CITY OF ALBUQUERQUE

Re: Sandia View Assisted Living
12501 Royal Ct. NE
Traffic Circulation Layout
Architect's Stamp 10-2-17(F22D015C)

Based upon the information provided in your submittal received 10-30-17, the above referenced plan cannot be approved for Building Permit until the following comments are addressed:

TCL-101

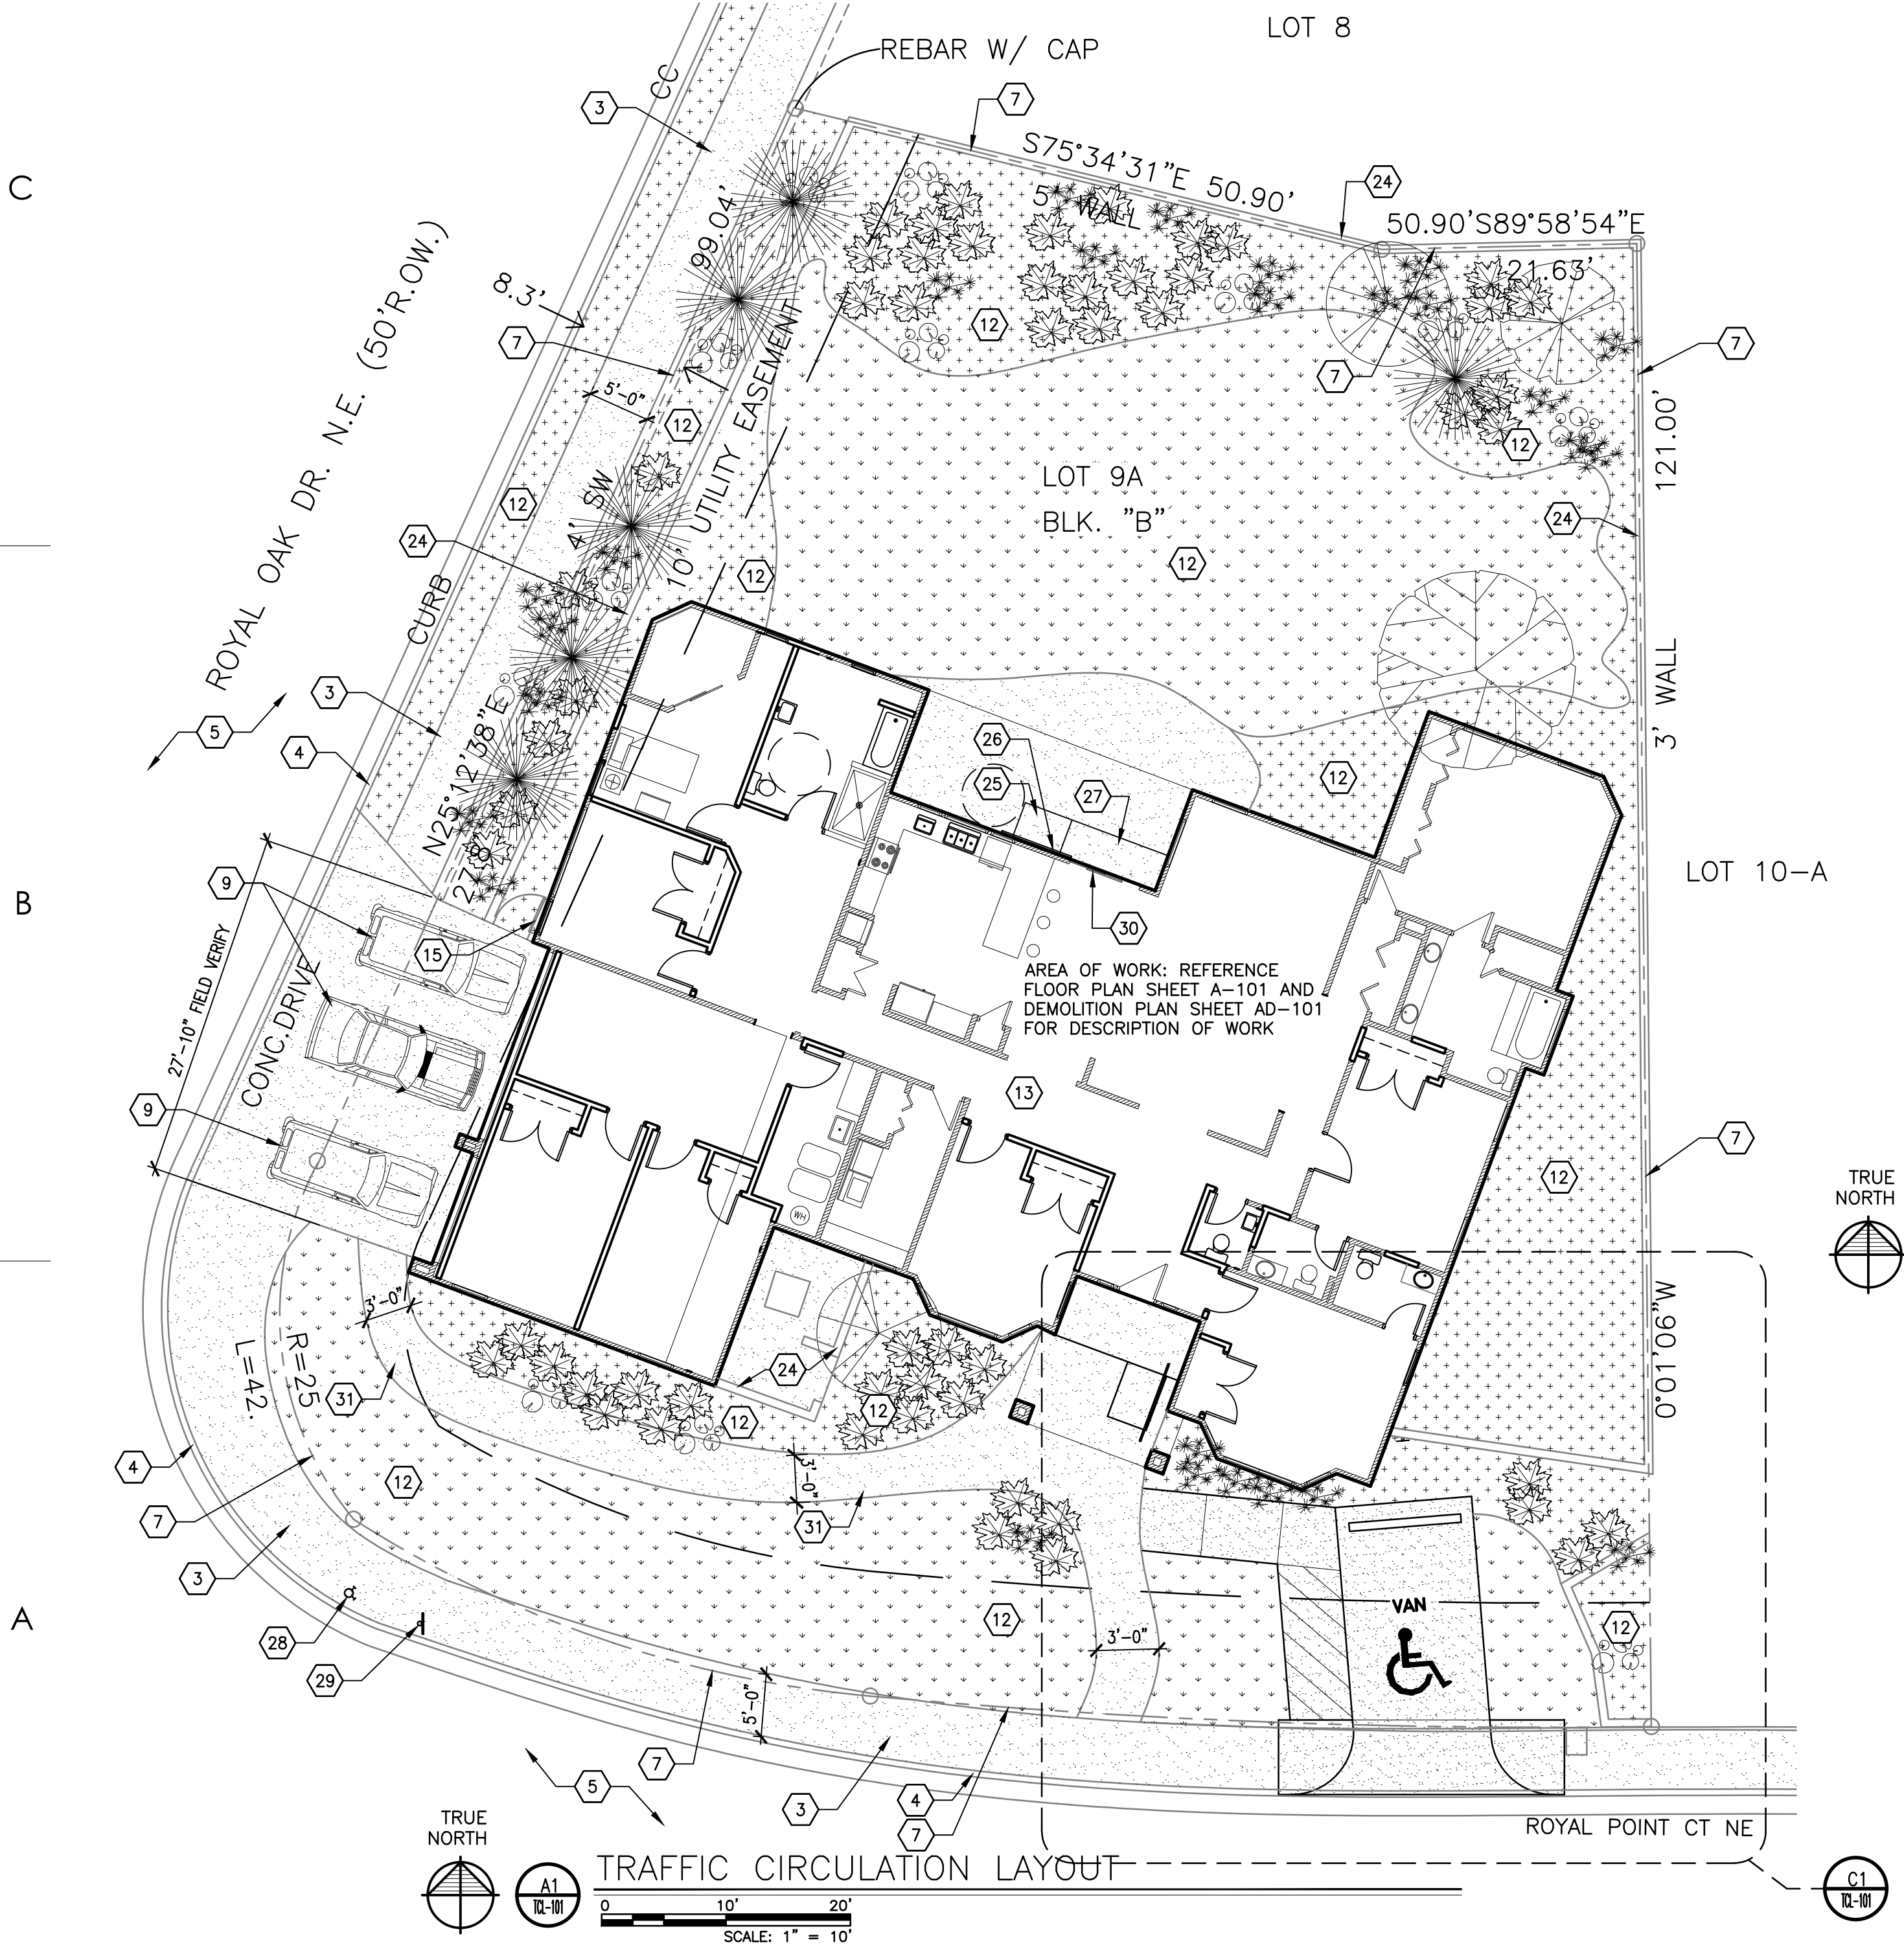
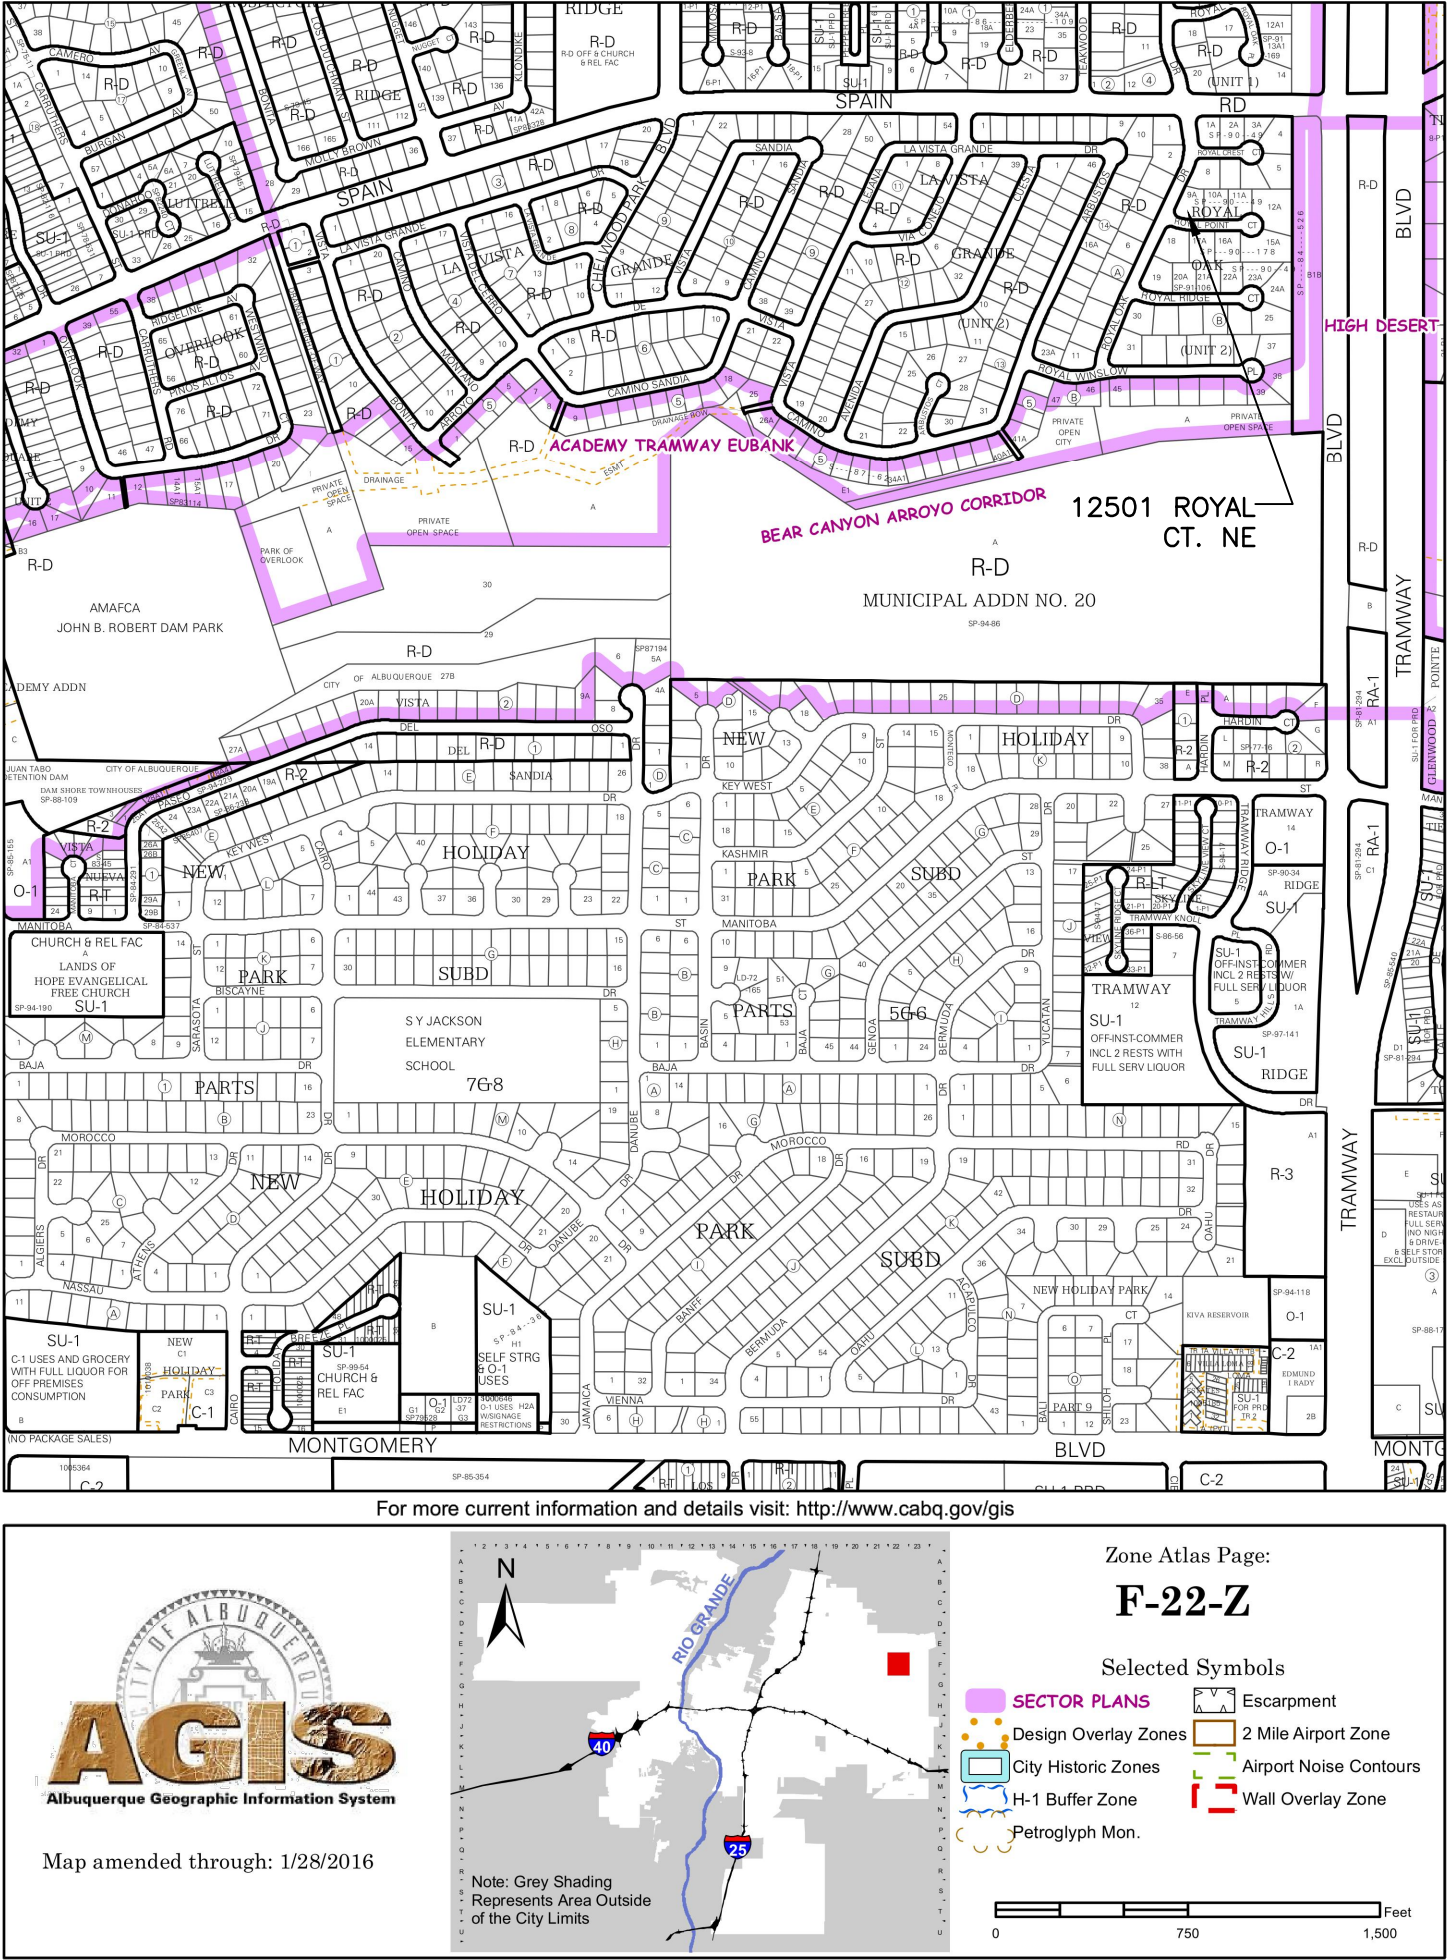
1. Per DPM, a 6 ft. wide ADA accessible pedestrian pathway is required from the HC parking stall access aisles to the building entrances. Please clearly show this pathway and provide details.
2. All parking spaces should be kept within the property line, and cannot over hang sidewalk.
3. Please revise notes 10 and 22. Maximum slope is 2% (1:50) for ADA accessible pedestrian pathway.
